**BELL BEND NUCLEAR POWER PLANT
RESPONSE TO RAI NO. 115 QUESTIONS
09.02.05-28 AND 09.02.05-34 AND
SCHEDULE INFORMATION
BNP-2012-184 Docket No. 52-039**

Response to RAI No. 115,
Questions 09.02.05-28 and 09.02.05-34

RAI No. 115**Question 09.02.05-28**

Figure 9.2-12 {ESWS Blowdown Line}

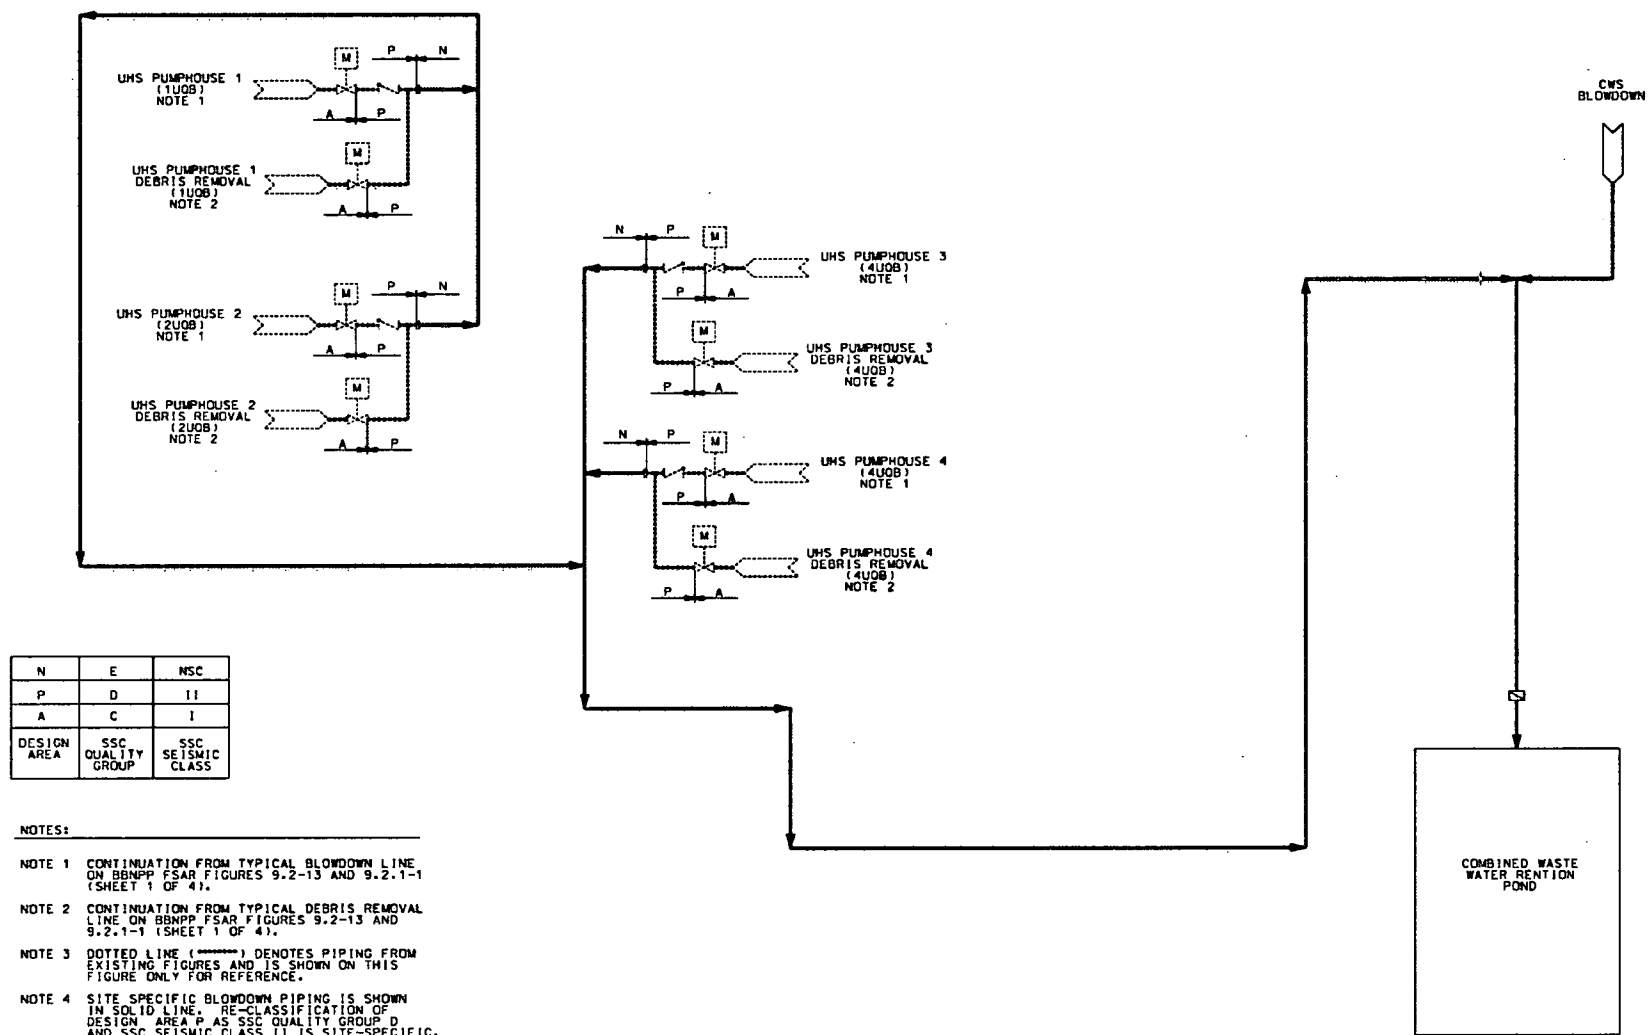
The staff's evaluation of the applicant's response and FSAR markup related to blowdown determined that clarification is needed related to the new drawings provided as FSAR markup shown on Figure 9.2-12, "EWS Blowdown Line."

- Safety-related to nonsafety-related boundaries should be added to Figure 9.2-12 clearly identifying the site specific design and certified design boundaries.
- Normal ESW strainer debris removal pipe appears to be missing from Figure 9.2- 12.

This scoping boundary and the debris removal pipe have been added to FSAR Figure 9.2-12. They already exist on Figures 9.2-13, 9.2-14, and 9.2.1-1, but have been included in Figure 9.2-12 for reference.

FSAR Section 9.2.5.1, Figure 9.2-12 and Figure 9.2-14 will be revised as follows in a future revision of the COLA:
